Subject: RE: LP-17-00007 Swauk Valley Ranch Updated Stream Mapping Information

Attached is a pdf of the information to update the unnamed tributary of Swauk Creek that runs west to east and near the proposed plat changes on Swauk Valley Ranch. This should help to square away the question on both stream location as well as stream type. On typing while it currently is a borderline call of between Type 2 and Type 3, it is a Type F (fish bearing) and under the new proposed CAO, the Type 2 and 3 will be going away to be replaced with Type F to make it consistent with DNR water typing maps.

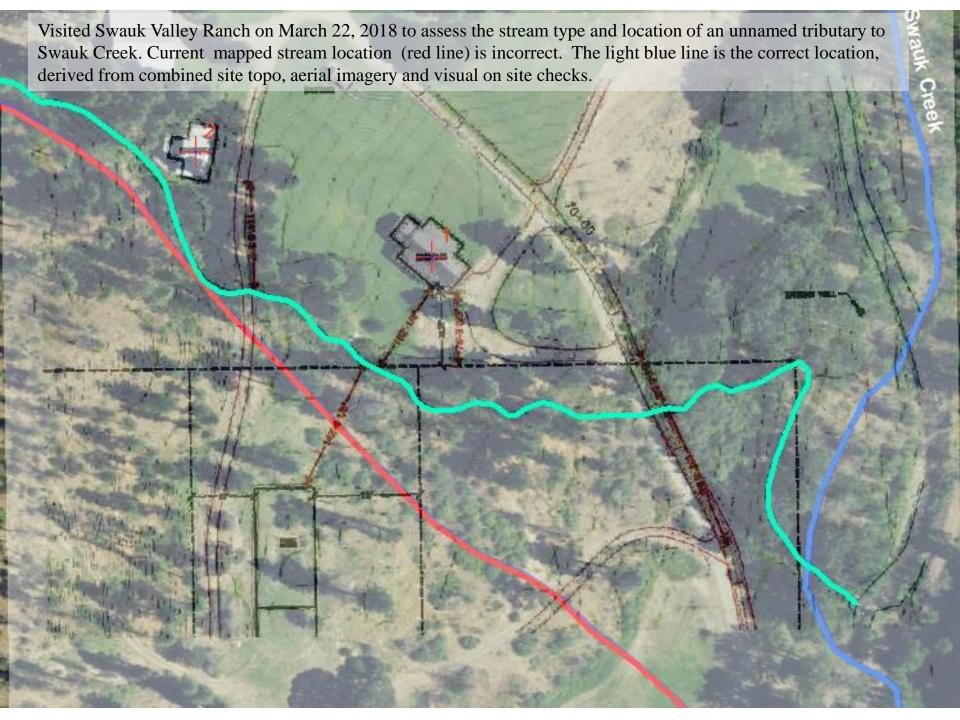
As a point of reference, the red numbers on the first slide don't relate to anything other than I had to georeference the topo site map with the aerial imagery.
